**GEH Licensing Topical Report NEDO-33440,
“ESBWR Safety Analysis - Additional Information,”
Revision 2, March 2010**

NEDO-33440

Revision 2

ESBWR Safety Analysis - Additional Information

RAI 6.2-98 S01 Figure 6.2-98 S01-1. DCD TRACG Nodalization of the ESBWR RPV

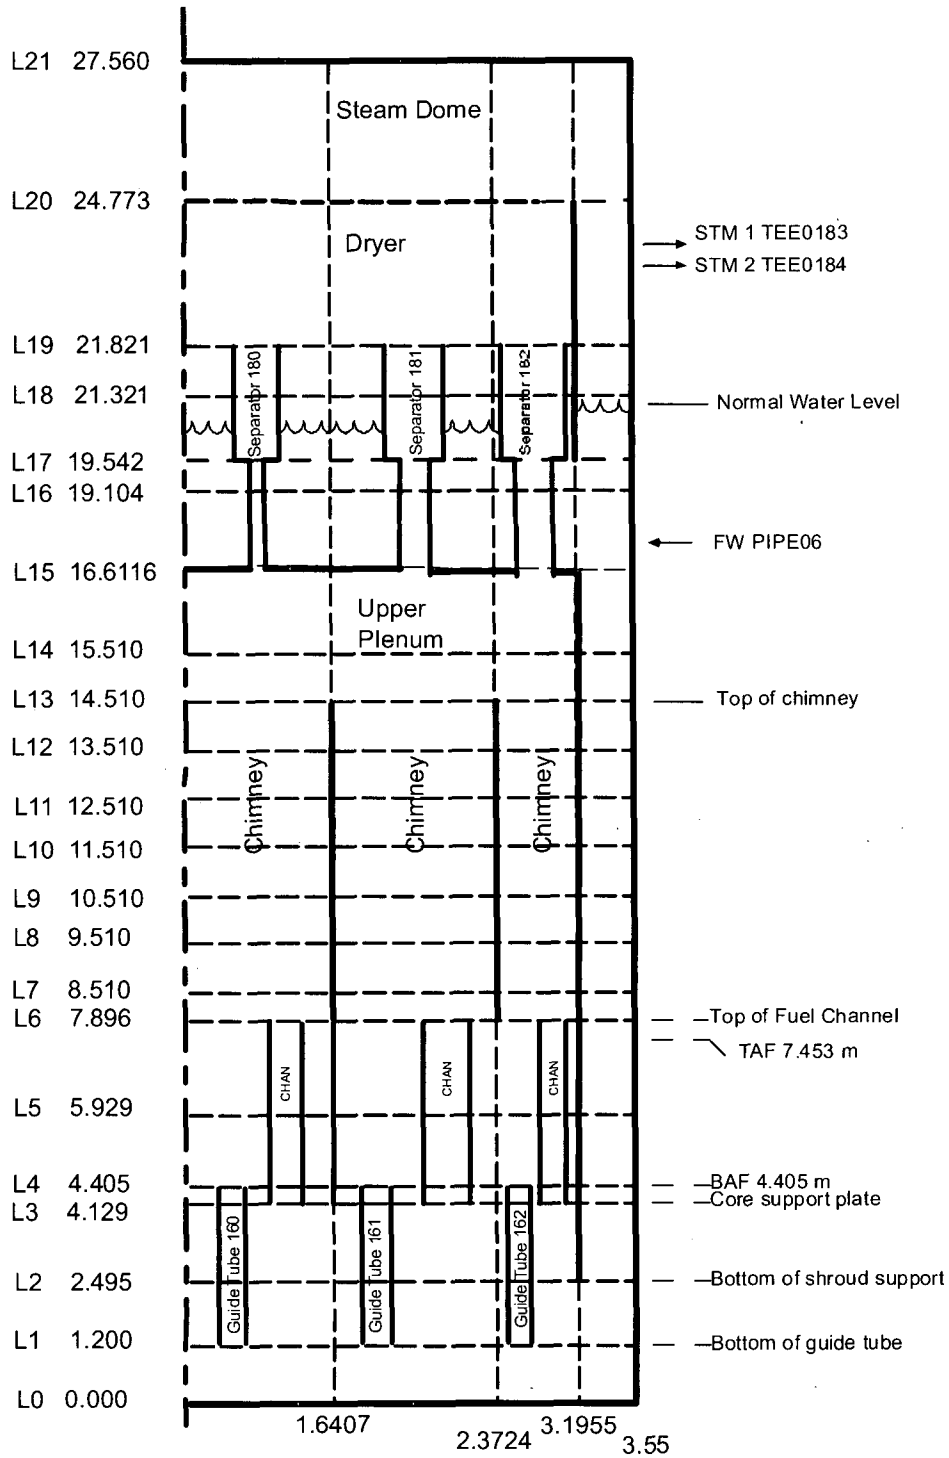
14. Provide all nodalization changes including diagrams since the approval of TRACG for ESBWR LOCA Analyses in Reference 2, include most recent changes incorporated into Rev. 2 of the DCD; Explain the statement in Reference 3 that a "Total of 5 chimneys to calculate the minimum water level." In the TRACG input decks submitted to the staff and in Figures 6.2-6 and 6.2-7, the core/chimney section is divided into only 3 rings.

Referring to the TRACG nodalization (Figures 6.2-98S01-1 and 6.2-98S01-2), the broken main steam line is located at Level 34 and discharges steam into the drywell (DW) at this elevation. Two pipes (per Gravity-Driven Cooling System (GDCS) airspace) are used to simulate the connection between the GDCS pool airspace and the DW (RAI 6.2-98 S01 Figure 6.2-98 S01-2), to purge the residual non-condensable (NC) gases in this airspace. For the NC gases, the nitrogen properties are used in these TRACG calculations.

**RAI 6.2-98 S01 Figure 6.2-98 S01-3. Containment Pressure Response
(72 Hours)**

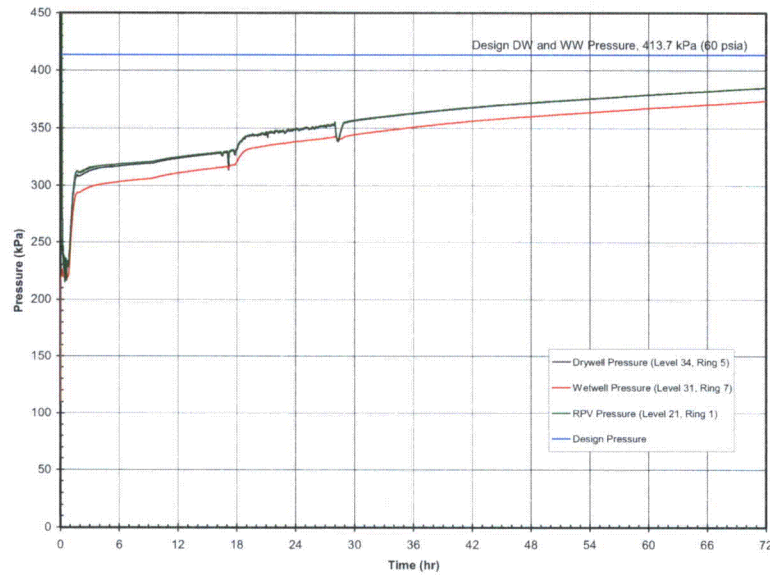
- (C) As shown on Figure 6.2-98-5, the noncondensable gas holdup in the drywell head region at 72 hours resulting in a pressure of 50 KPa is significant. Please (1) provide the mass of noncondensables held up in the drywell head region and (2) quantify the effect on the drywell pressure, if the noncondensables held up in the drywell head and GDCS pools were transferred to the wetwell.

RAI 6.2-98 S01 Figure 6.2-98 S01-3 shows the reactor pressure vessel (RPV), DW and wetwell (WW) pressures, and RAI 6.2-98 S01 Figure 6.2-98 S01-3a shows the same responses in short-term time scale.
